Work Order ID 83058

Item Name: Crosstube Fwd

DRAWING NO. D212-664-141	TITLE XTUBE ASSY (205/212/412 HI FWD)	REV. D	DART AEROSPACE LTD ENGINEERING ORDER	D.E.O. NO. D212-664-141-D-1	SHEET NO. SHEET 2 OF 2	SCALE NTS
DRAWN	CHECKED <i>CP</i>	MFG. APPR. <i>E</i>	APPROVED <i>WAD</i>	DE APPR. <i>WAD</i>		
DATE 11.04.07	DATE 11.04.11	DATE 11.04.12	DATE 11/04/12	DATE 11.04.12

DRAWING NO. D212-664-141	TITLE CROSSTUBE ASS'Y (205 HI FWD)	REV. D	DART AEROSPACE LTD ENGINEERING ORDER		D.E.O. NO. D212-664-141-D-2	SHEET NO. SHEET 1 OF 1	SCALE NTS
DRAWN <i>UP</i>	CHECKED <i>ASS</i>	MFG. APPR. <i>AB</i>	APPROVED <i>MD</i>		DE APPR. <i>TH</i>		
DATE 11.07.15	DATE 11.07.20	DATE 11.07.21	DATE 11/07/21		DATE 11.07.21

**D212-664-141/-141B
ASSEMBLY DETAIL**

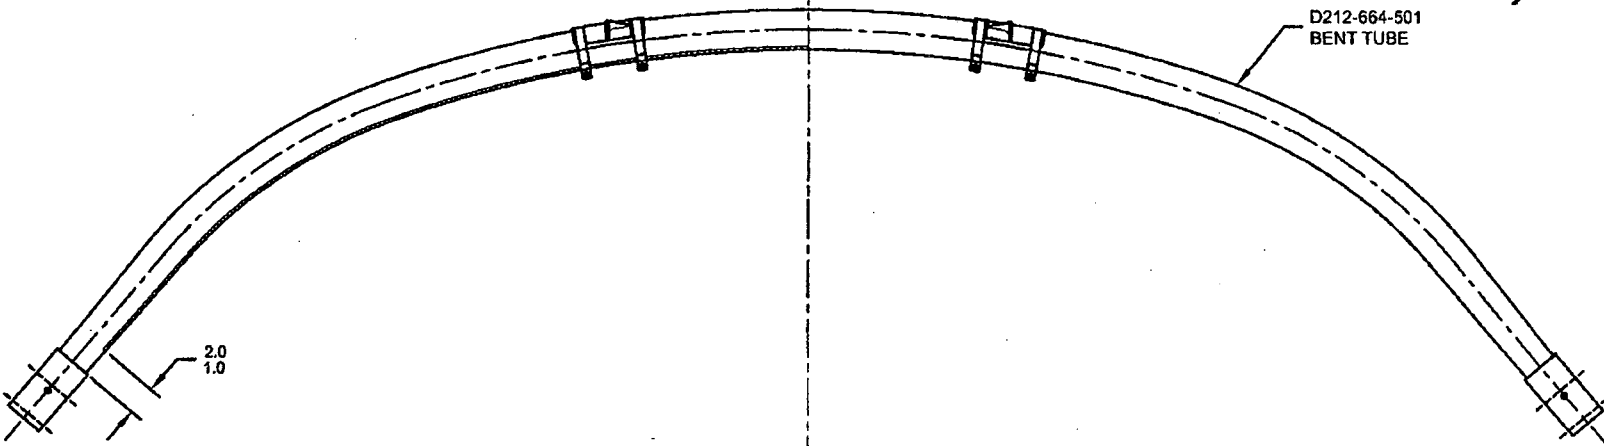
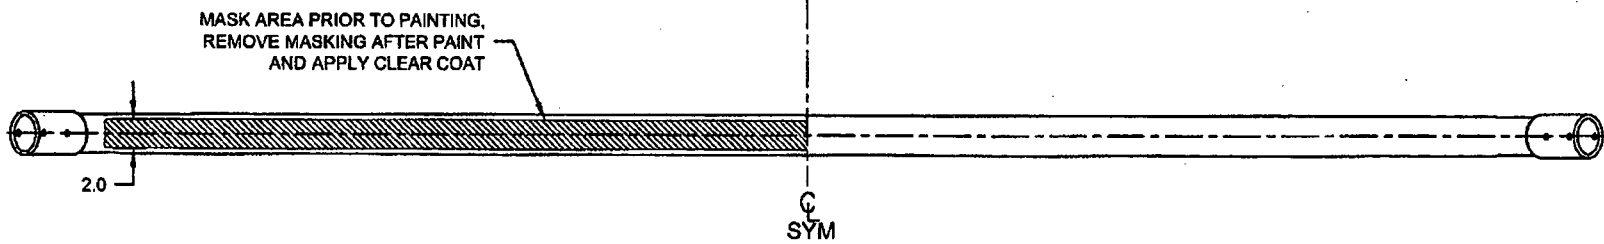
IS:

WAS:

*ECN# 11-614
11.07.28*
